Intel® E8501 Chipset North Bridge (NB)

Specification Update

May 2006

Document Number: 309622-001

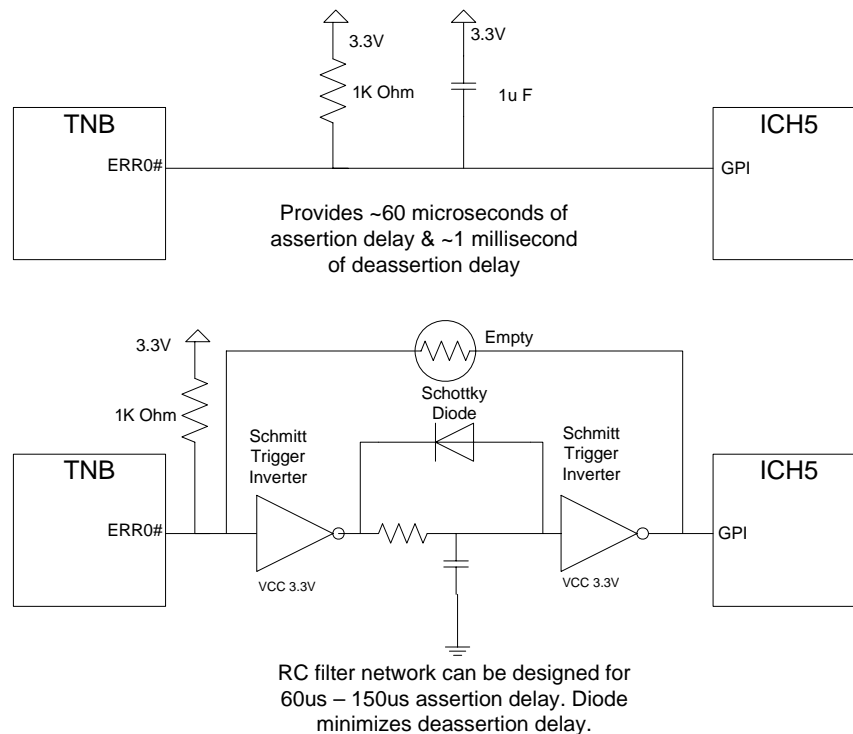
Problem: Any condition routed to MCH ERR[2:0]# output pins for SMI# escalation that would result in data poisoning on FSB will result in a CPU IERR# assertion due to race condition. The race condition exists between poisoned data presented to the FSB by the MCH and the uncorrectable error escalated to SMI# via ERR[2:0]# pins. If the CPU observes an SMI# assertion before the poisoned data is presented to the FSB, the CPU asserts MCERR# followed by IERR#. The CPU expects the SMI# assertion to occur at least 10 BCLKs after the associated MCERR# assertion. Conditions that result in data poisoning on FSB are uncorrectable memory ECC errors or poisoned TLPs received from any PCI Express* port.

Implication: CPU may assert IERR# and cause a system hang before the error may be logged in SMM.

Workaround: The following workarounds have been identified:

1. Log errors upon reboot
 - System components (TNB, CPU, Southbridge) preserve errors across warm resets via sticky error registers
 - Requires a mechanism to reset system upon IERR# (server management controller, depress system reset button, etc.)
2. Delay SMI# assertion by inserting a 60µs-150µs delay on the ERR0# pin
 - Two recommended circuit solutions (other solutions may be possible):

- Route errors that result in FSB data poisoning to the ERR0# pin (IO4, M2, M4-13, M15)
3. Disable FSB data parity (ECC on Potomac/Tulsa) checking on CPU
 - Prevents CPU from asserting MCERR# on poisoned data
